CITY OF COSTA MESA

SUBJECT: FIRE STATION NO. 2 RECONSTRUCTION, CITY PROJECT NO. 26-05 - ADDENDUM NO. 1

This addendum, effective on this date, addresses the following items:

- Added Pre-Bid Requests for Information Questions and Answers
- Added PBK Addendum letter dated September 15, 2026
- Revised drawings, specifications, and reference documents

DRAWING NUMBER: S4.1

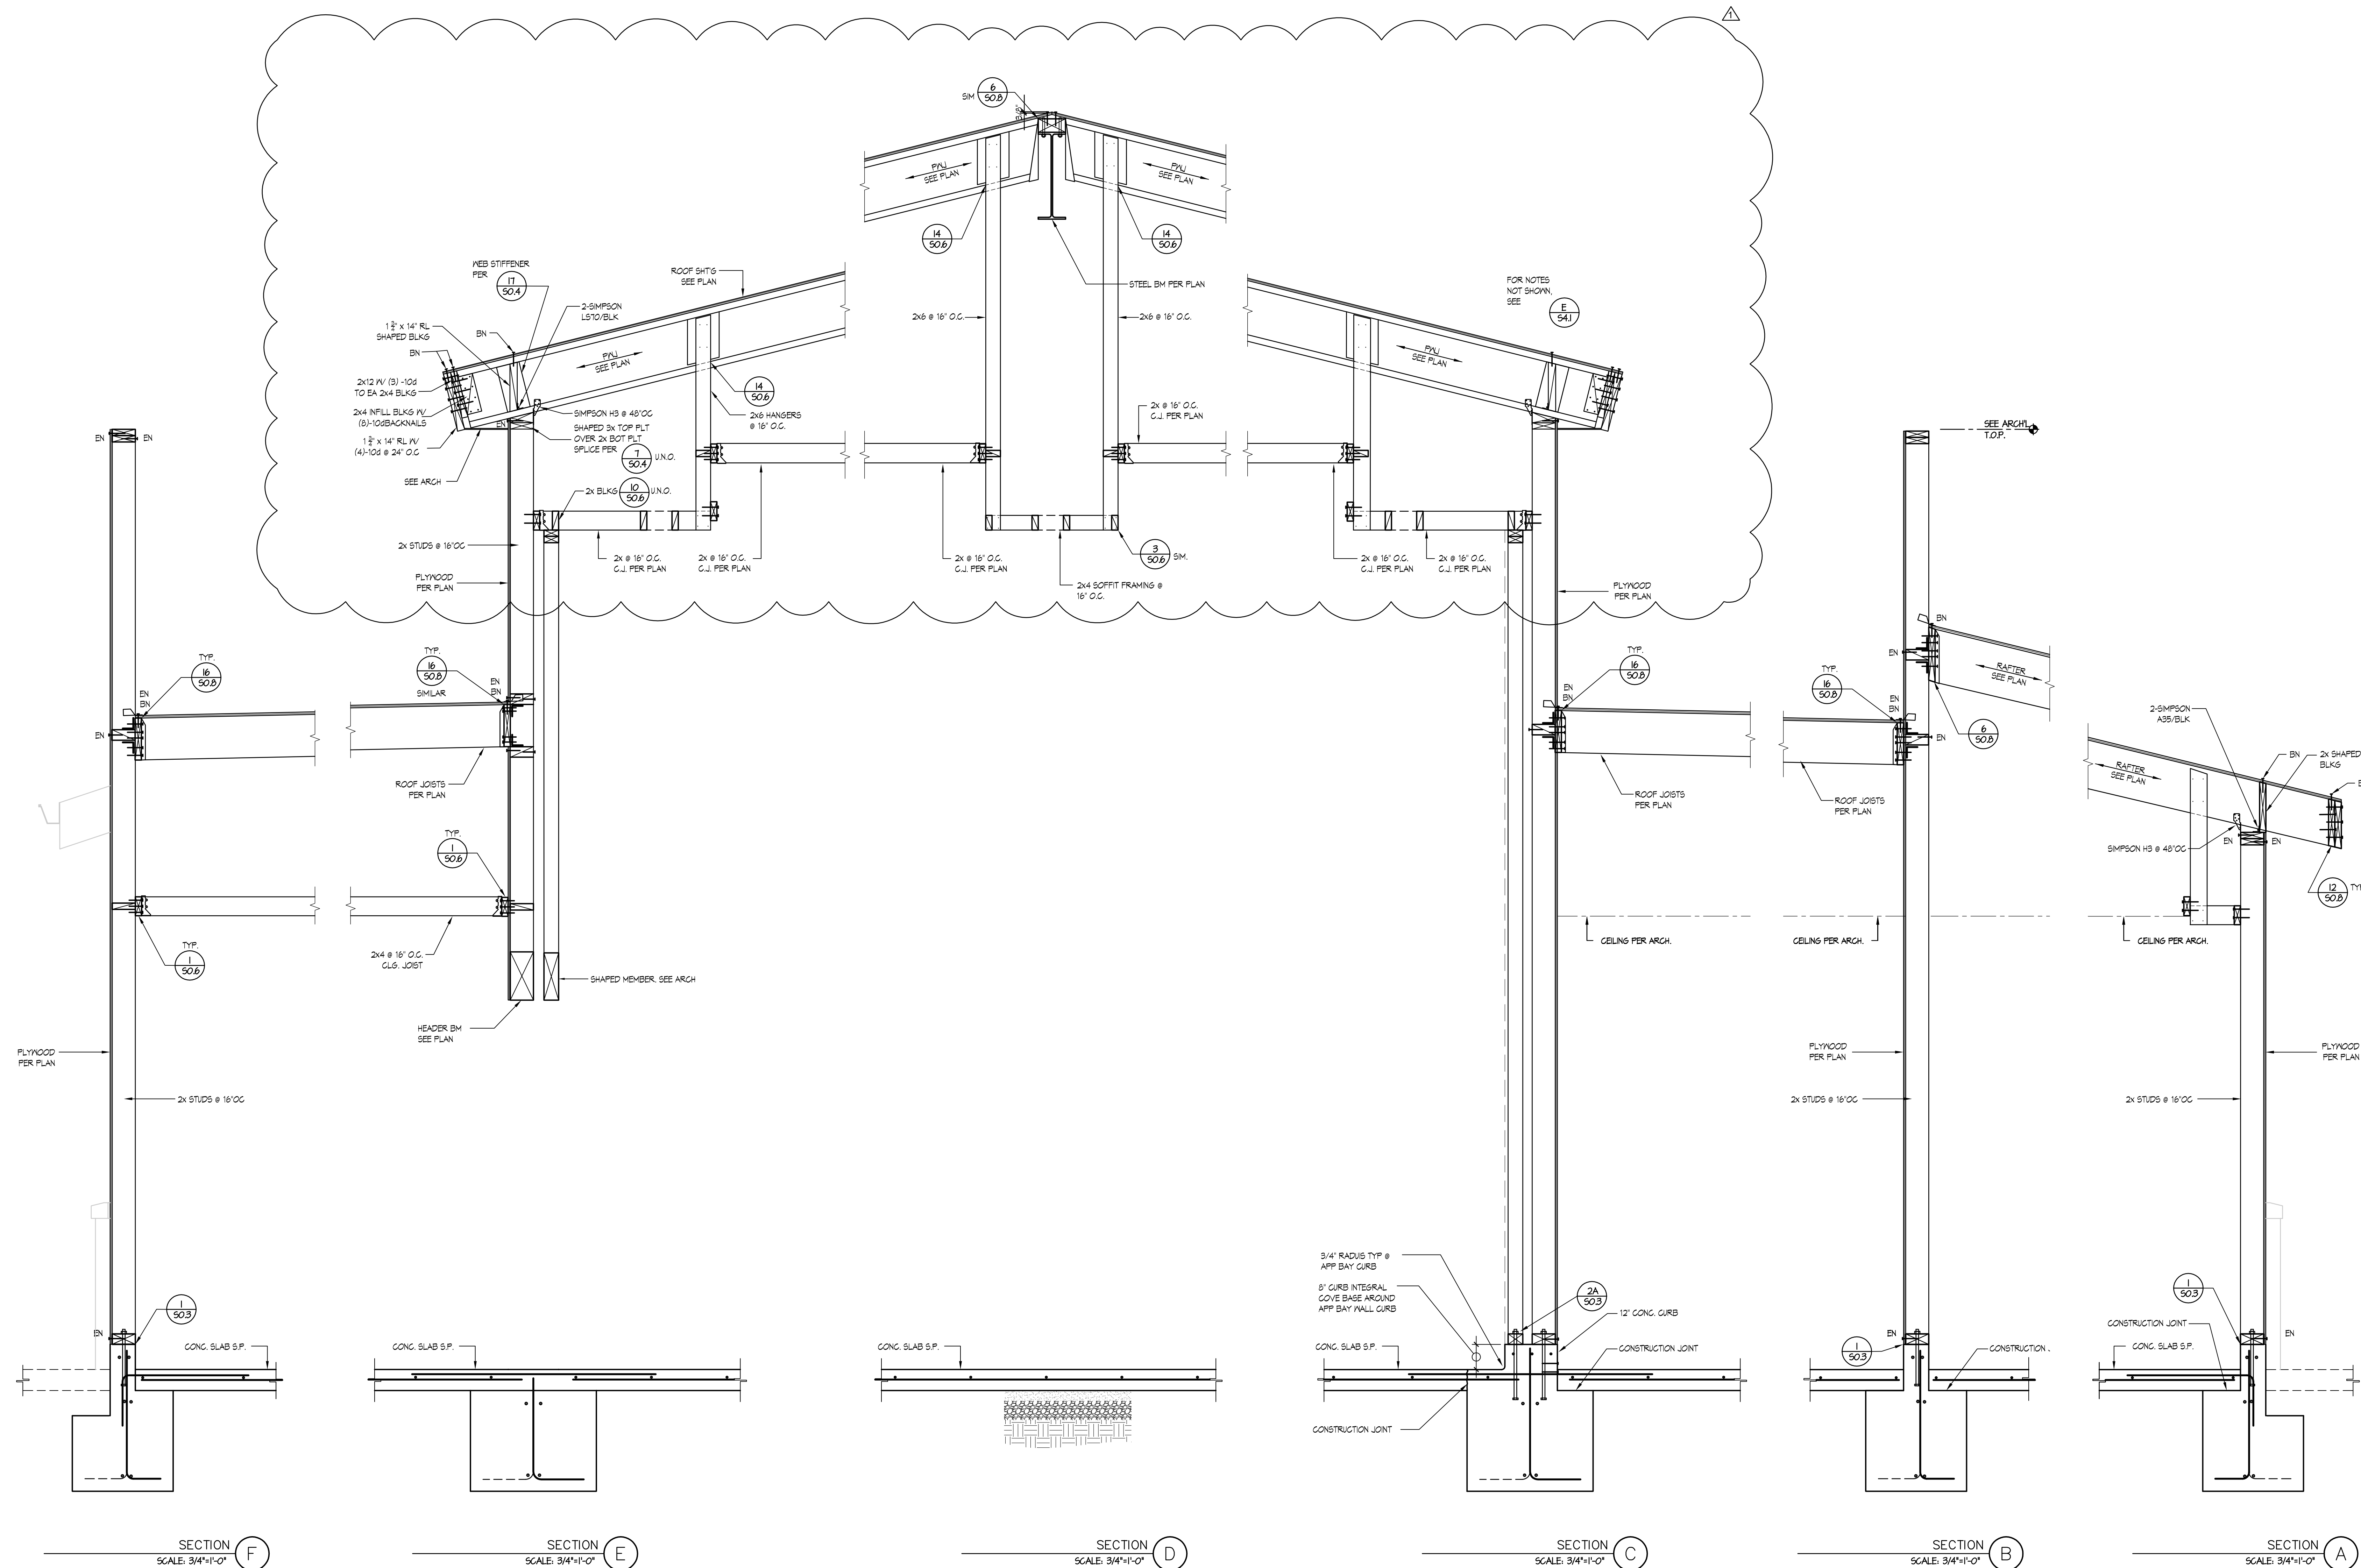
61	S4.1 Details E & C call the high-roof overhang to Detail 12/S0.8. 12/S0.8 is drawn for 2x10 rafters notched at the wall. High roof on S3.2 is 14" Red-I65 I-joists (RJ-14), not 2x10s. You can't notch an I-joist like a 2x10. Please give us a detail like 12/S0.8 that works for the 14" Red-I65 tail / overhang. Need to know: • How the I-joist sits on the wall • How far it hangs out • How we cut the tail • How fascia and soffit attach • What hardware to use Reference: Sheets: S4.1, S0.8, S3.2	Detail 12/S0.8 and Sections C & E on S4.1 are updated to show I-Joist overhand and fascia attachment.
62	Phasing Demolition / New Plans sheet A1.0_D shows at Baker Street side at existing Fire Station driveway, one Contractor Trailer CFCI and one CM Trailer CFCI. Will be acceptable for GC to lease an office space across the street and have that space shared as GC office and CM office?	Yes, as long as the offices are within half a mile of the project site, the GC and CM offices are separated by a full height wall, and all provisions and amenities of the specifications are provided.

- A. REPLACE: Sheet in its entirety with the attached S4.1. Revisions clouded.

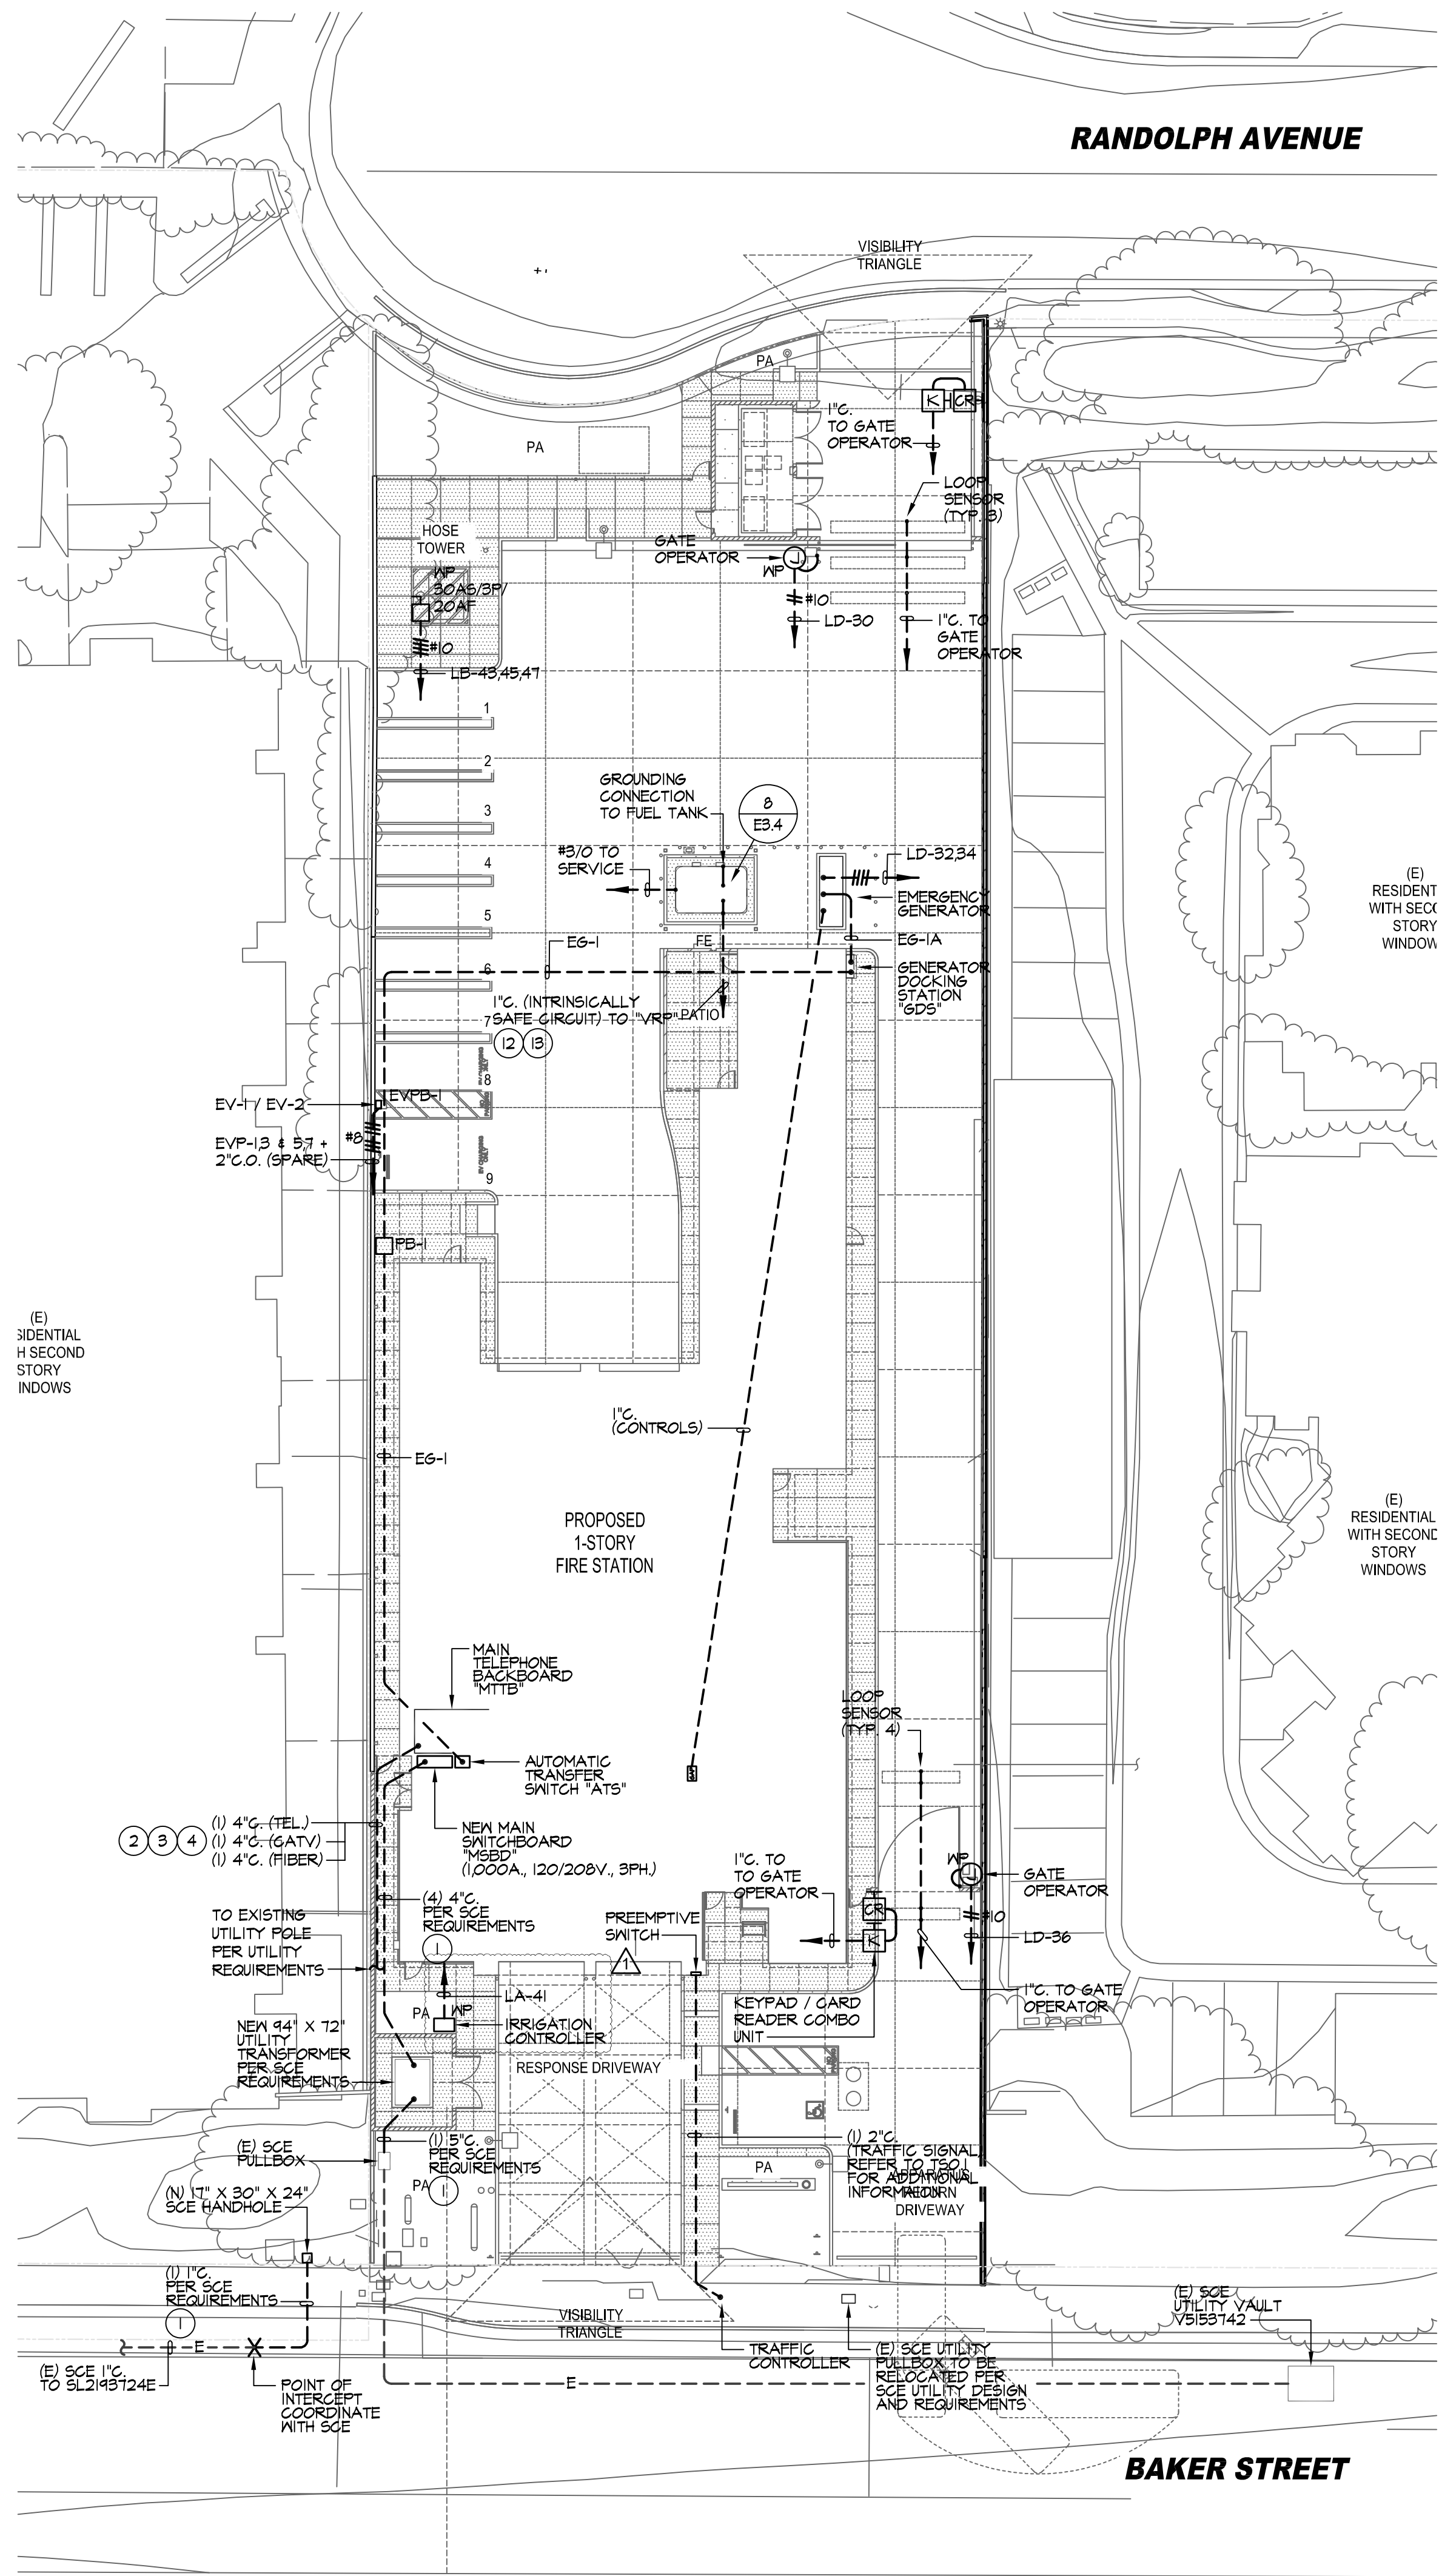
53	The E0.3 panel schedule feeds "ROLL-UP DOOR RUD-1" and "RUD-2" and "BI-FOLD DOOR #1" and "#2"; Spec 08 35 00 specifies Four-Fold Doors at the apparatus bay; Spec 08 33 23 covers Overhead Coiling Doors; a general plan note addresses "ROLL-UP, SECTIONAL, BI-FOLD, ETC." door installation; and the door schedule indicates coiling doors at Rooms 129B, 134 and 135. Please reconcile door types, counts and locations across the documents, identify which doors are motorized and their electrical requirements, and confirm the apparatus bay door type and count. Reference: Sheet E0.3 Panel "LC"; Sheet A5.1 Door Schedule and Notes; plan note 9 (roll-up/sectional/bi-fold installation); Specs 08 35 00 and 08 33 23; Sheet A2.1 Floor Plan.	All power requirements for motorized doors are reflected on sheet E2.4. Typo on identification of motorized doors as there are coiling doors and four-fold doors. Refer to Architectural sheet A5.1 door schedule for types of doors to be provided and installed in apparatus bay.

54	Panel LA on Sheet E0.3 carries a breaker labeled "EMS CONTROLS," and the commissioning sections reference a Building Automation System — but the VRF controls are LG (LGRED) per Sheet M0.2 and no BAS/EMS section exists (no 23 09 xx or Division 25). Please confirm what system the "EMS CONTROLS" circuit feeds, whether a building automation or energy management system beyond the VRF controls is required, and provide its specification if so. Reference: Sheet E0.3 Panel "LA"; Sheet M0.2 Fan Coil Unit Schedule notes; Specs 01 91 13 and 23 08 00 (Building Automation System references); Volume 2 (no BAS/EMS section).	A full EMS system is not being provided but a central controller is. Panel LA, circuit #42 is dedicated to energize the central controller.
55	The demolition plans require removal of the existing 1,000-gallon double-walled fuel tank "UNDER SEPARATE PERMIT" with compliance to the OCHCA Tank Removal Guidelines, including soil sampling per Section 7 and advance agency notification of the backfill source — but no specification section covers the removal and no bid item identifies it. Please confirm: (a) who obtains and holds the OCHCA closure permit and whether the agency application lead time fits within the Phase 01 duration; (b) that the contractor is not assigned responsible-party status or any post-closure monitoring obligation; (c) the required backfill laboratory testing scope, and whether quarry-sourced material with supplier certification is exempt under current OCHCA guidance; (d) how contaminated soil discovered at the tank pit is paid (Allowance Nos. 01/02 or unit prices); and (e) the license classification required of the tank-removal subcontractor. Reference: Sheet D-1.01 tank-removal keynote and "NOTE TO CONTRACTOR REGARDING FUEL TANK REMOVAL" (OCHCA Tank Removal Guidelines, Section 7); Sheet A1.0_A Phase 01; Volume 1 Article SP-06 Allowance Nos. 01-03; Volume 1 Notice Inviting Bids (Class B license); Volume 1 Article SP-11.	Contractor shall obtain and hold all permits. Contractor is responsible for all requirements identified in the OCHCA tank removal guidelines.

- A. REPLACE: Sheet in its entirety with the attached E0.3. Revisions clouded.
